STREET A PLAN AND
PROFILE

PARKER RIDGE
82 SCHOOL STREET
ROLESVILLE / NORTH CAROLINA / 27571

08/01/2023 PER TOWN OF ROLESVILLE COMMENT

STREET C PLAN AND
PROFILE (1 OF 2)

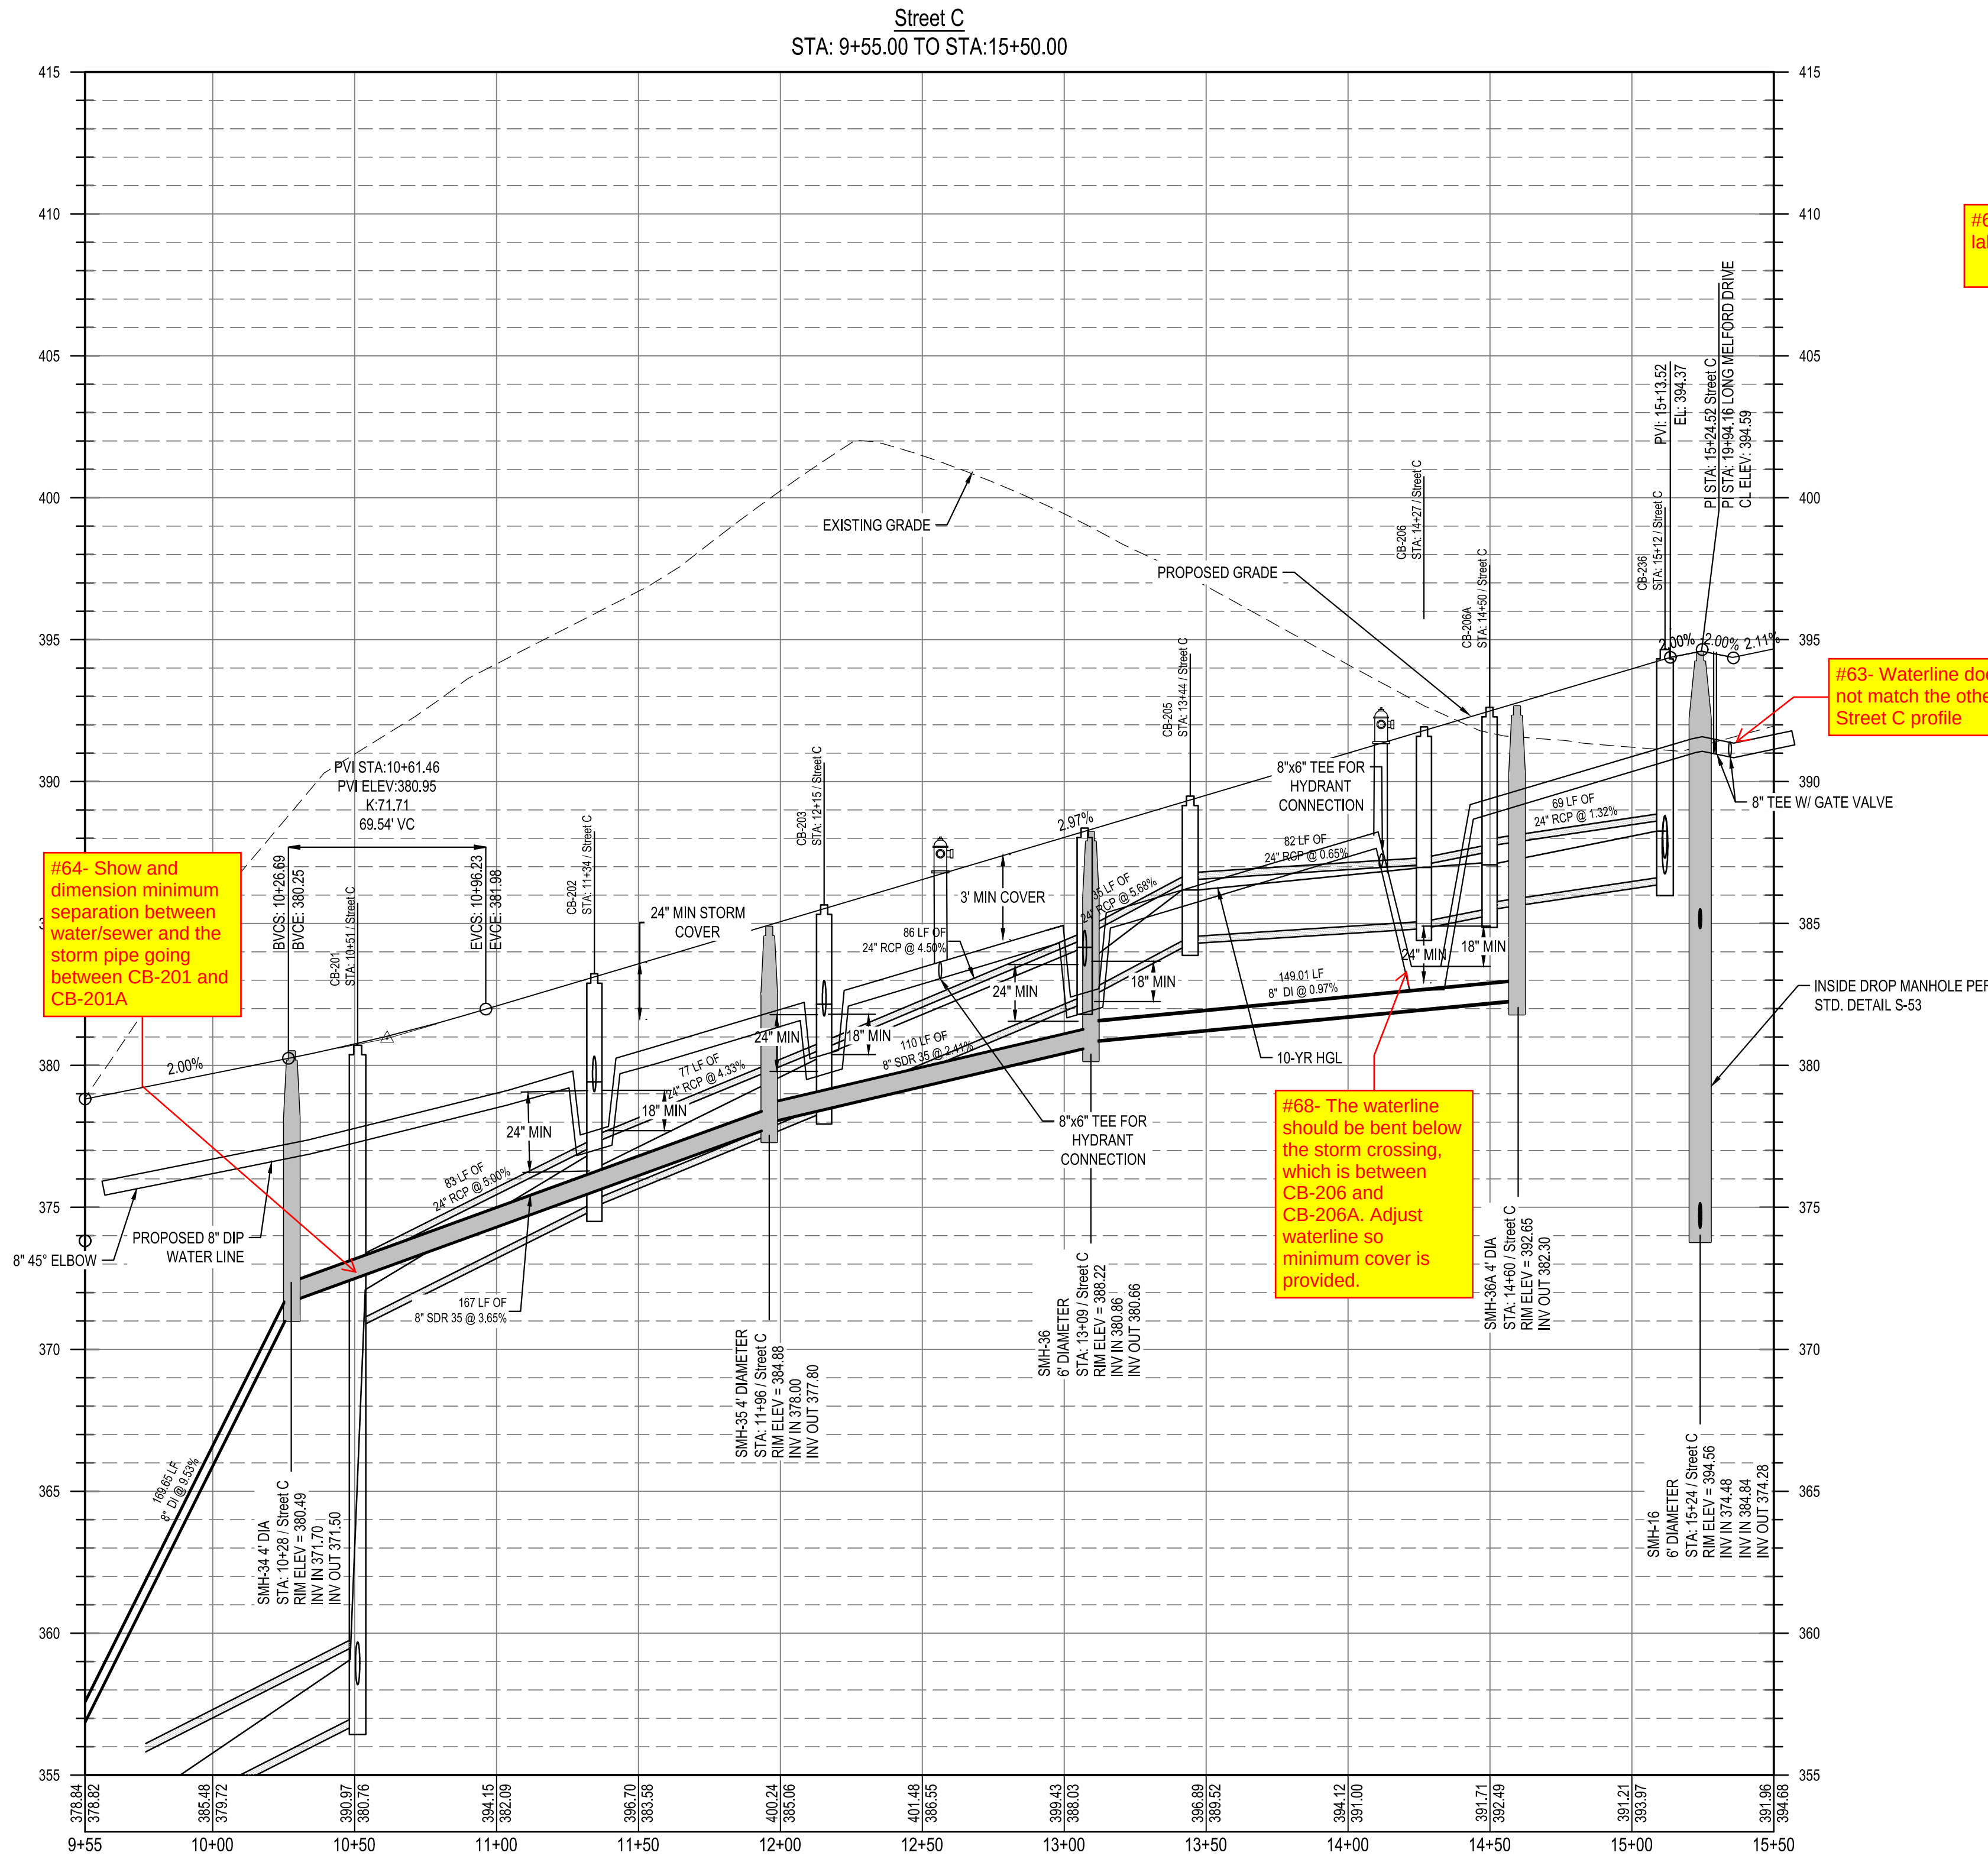
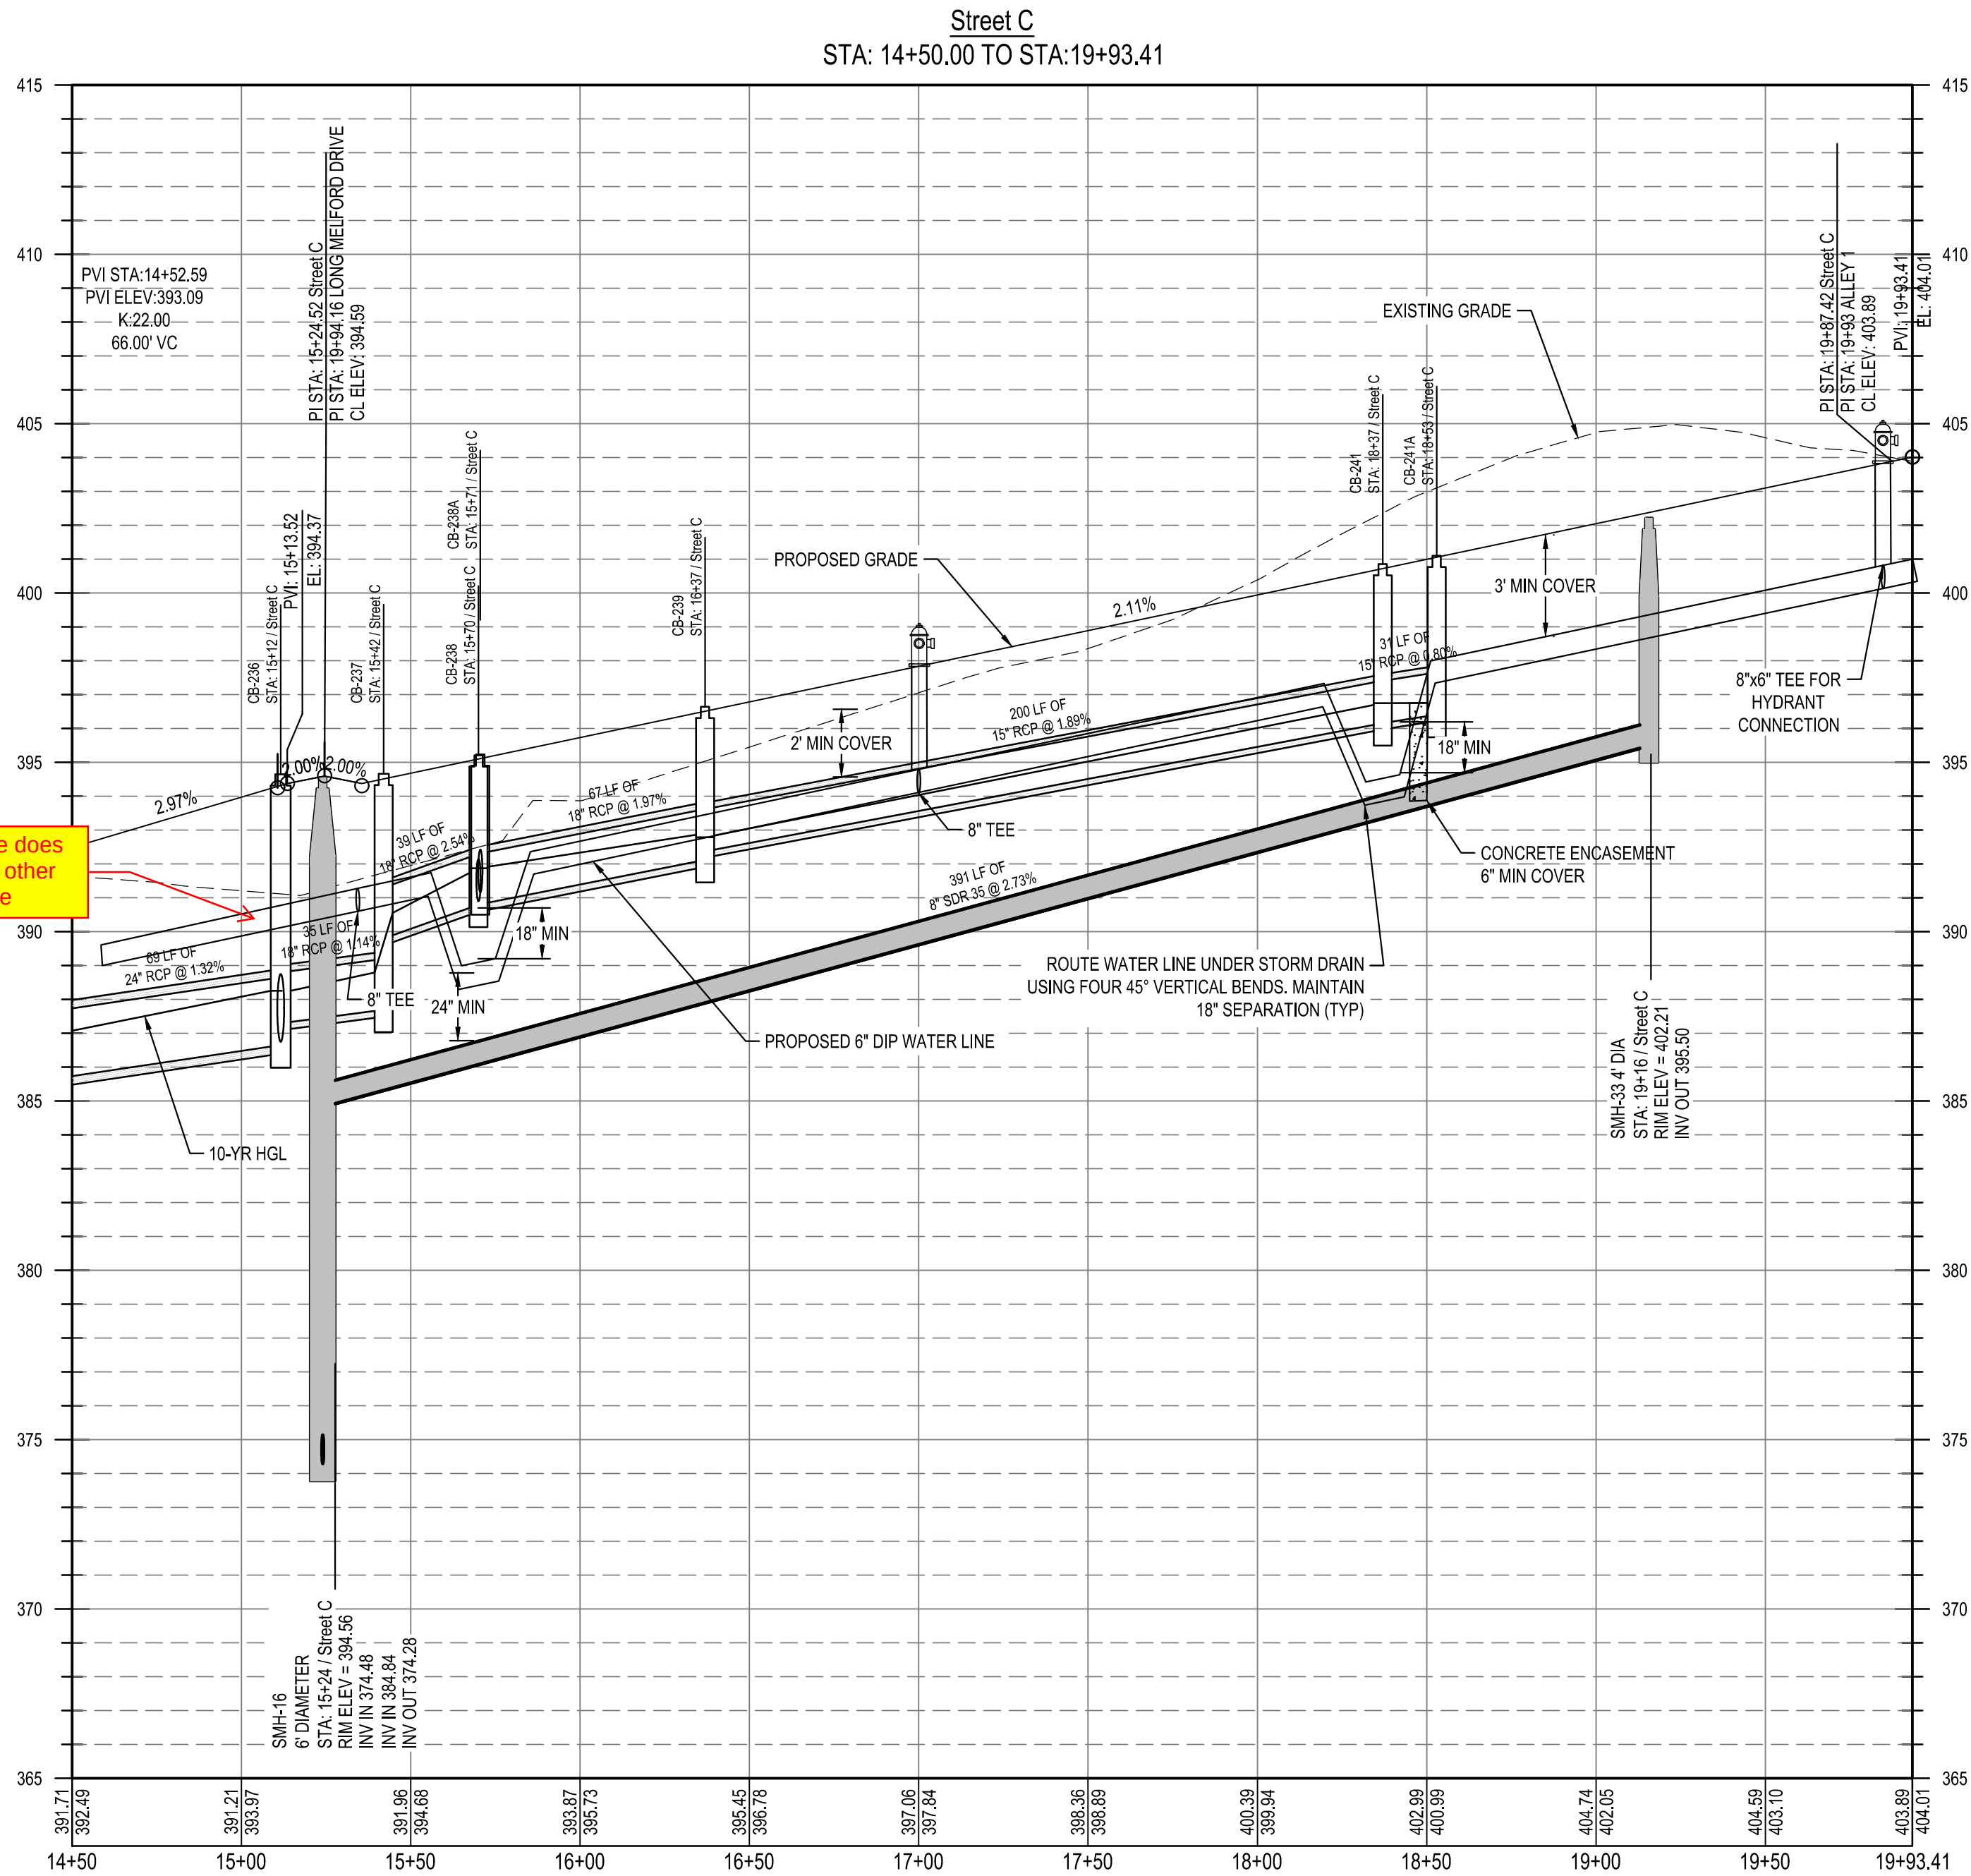
#69- If vertical bends are to be used, please label them.

#68- The waterline should be bent below the storm crossing, which is between CB-206 and CB-206A. Adjust waterline so minimum cover is provided.

#63- Waterline does not match the other Street C profile

#62- There are several locations where the dimensions don't seem to line up with top/bottom of pipes. Please make sure it is clear what is being dimensioned. If crossings are not meeting minimum requirements, design will need to be adjusted.

#63- Waterline does not match the other Street C profile
